Office Action Summary

10/715,376

DETAILED OFFICE ACTION

**FIG. 3**10

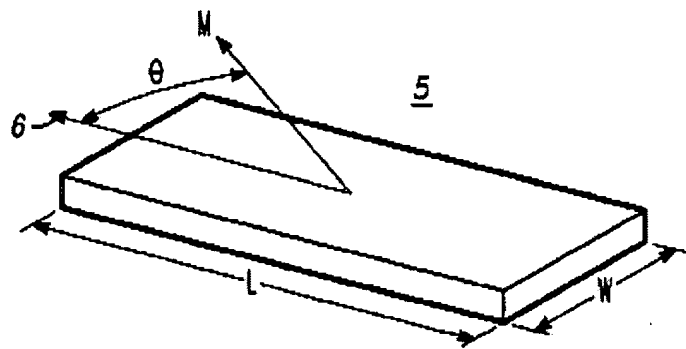
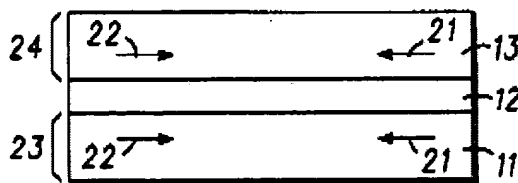
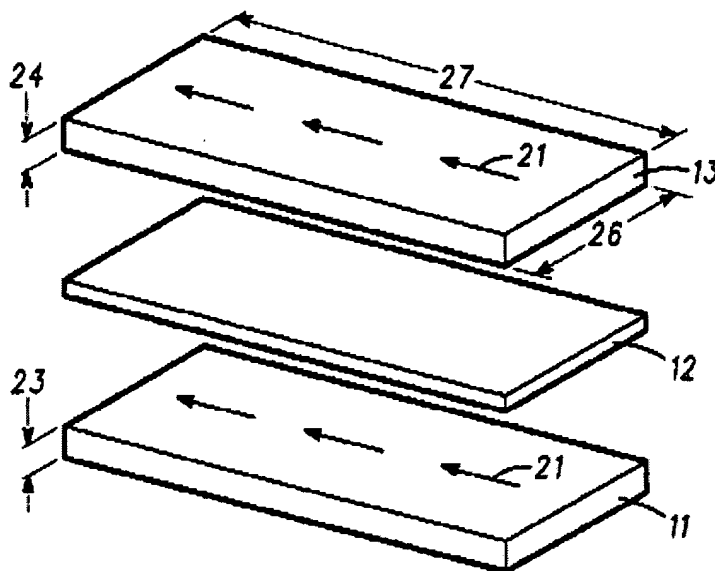
Chen (fig 1,fig2,fig 3, column 2 lines 40-44,column 4 line 40) discloses magnetic memory element, comprising: a plurality of magnetic layers, at least one of the plurality of magnetic layers (fig 3 layer 11,13) having a perpendicular magnetic anisotropy component and

comprising a current-switchable magnetic moment; and at least one barrier layer(fig 3 layer 12) formed adjacent to the plurality of magnetic layers.

Noted that since Chen discloses a MRAM magnetic spin memory device that use current switching (column 2 line 2) to switch the magnetic moment of its cell. Noted that as set forth in paragraph 5 of the Office Action , the limitations in the preamble are not accorded any patentable weight. Noted that for most MRAM the switching effect is due to the switching of the write current of the word line either indirectly through the magnetic moment or directly through the MRAM stack.

FIG. 9

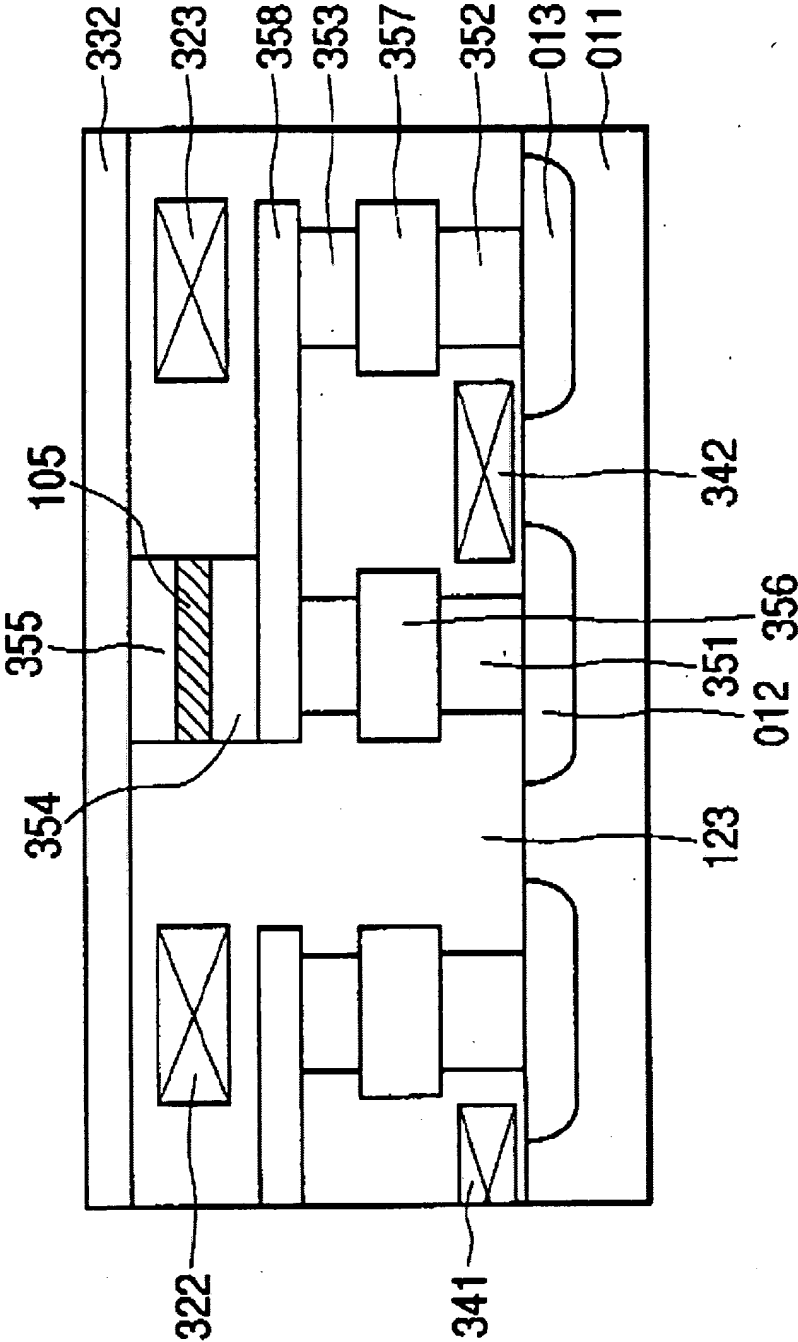
Ikeda (in the abstract , in fig 9) discloses a magnetic memory element, comprising: a plurality of magnetic layers (fig 9 layer 355,354), at least one of the plurality of magnetic layers having a perpendicular magnetic anisotropy component (the abstract lines 3-4) and comprising a current-switchable magnetic moment; and at least one barrier layer (fig 9 layer 105) formed adjacent to the plurality of magnetic layers. Noted that Ikeda discloses a tunneling magnetoresistive device (column 7 lines 5-6) therefore it is inherently a spin current switchable magnetic memory device. Noted that for most MRAM the switching effect is due to the switching of the write current of the word line either indirectly through the magnetic moment or directly through the MRAM stack.

Ikeda (in the abstract , in fig 9) discloses a magnetic memory element comprising: first and second leads (fig 9 layer 332 layer 358) ; and a pillar formed between said first and second leads, said pillar including said at least one barrier layer (fig 9 layer 105) and at least one magnetic layer (fig 9 layer 354 or 355) of said plurality of magnetic layers.

With regard to claim 12, as set forth in the rejection of claim 8, Ikeda (the abstract, fig 9) discloses all the invention except for a lead or electrode that includes a magnetic layer. Nakada, however, (in fig 1, column 4 line 58-65) discloses a lead (layer 12) that can includes a magnetic layer 13.
